Mercedes-Benz in-tank modules

Replacement part solution for CLS- and E-Class

Fig. 1: Comparison of fuel delivery modules

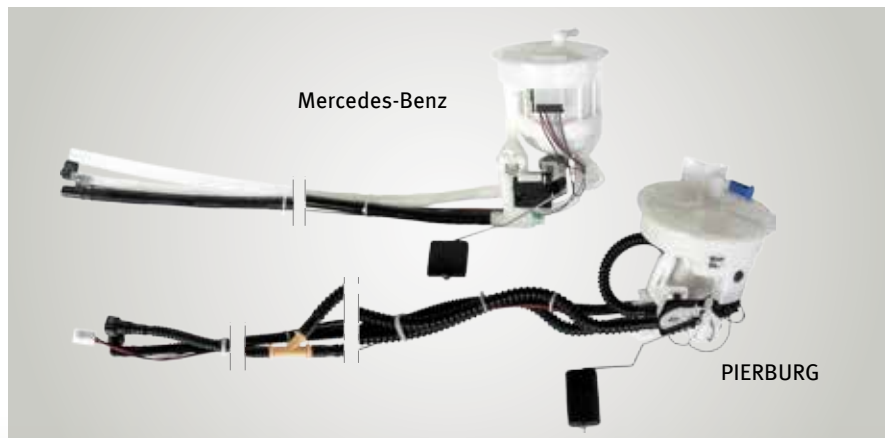
The fuel delivery module and fuel tank sender unit which Motorservice offers for the vehicles listed above are different from the components installed by the vehicle manufacturers.

These differences are partly due to patent law, and partly to a continuous improvement process:

- The fuel delivery module from Motorservice features carbon-carbon commutation and therefore conforms to regulation E10.
- The fuel delivery module from Motorservice has a lower current consumption with the same performance (4.4 bar at 13.5 V).
Motorservice: 100 W, 7 A
Manufacturer: 162 W, 12 A
- On the fuel tank sender unit from Motorservice, both return lines are joined into one line by a Y-connector.

Fig. 5: Flange cover of the fuel tank sender unit

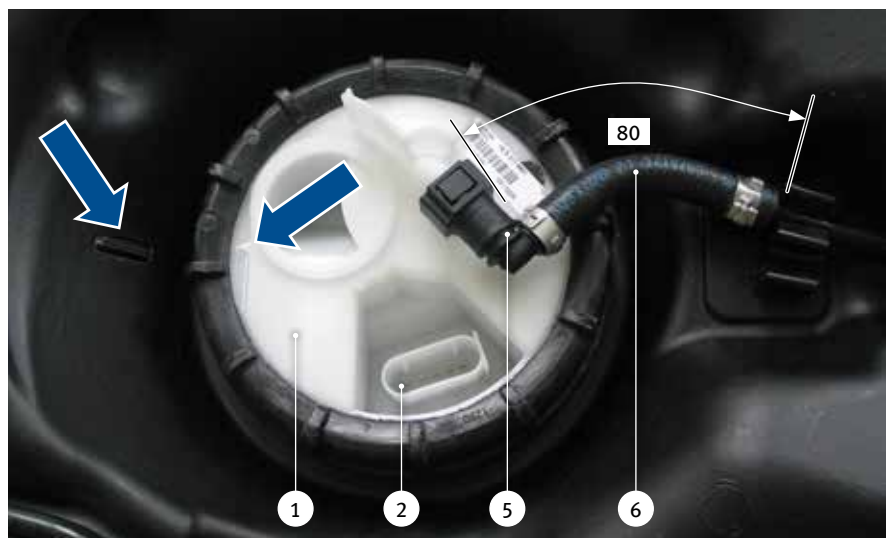
When replacing the fuel tank sender unit (1), the piece of tubing (6) of the flow line must be shorted to approx 80 mm, and the 90° quick connector (5) enclosed must be mounted (Fig. 5).
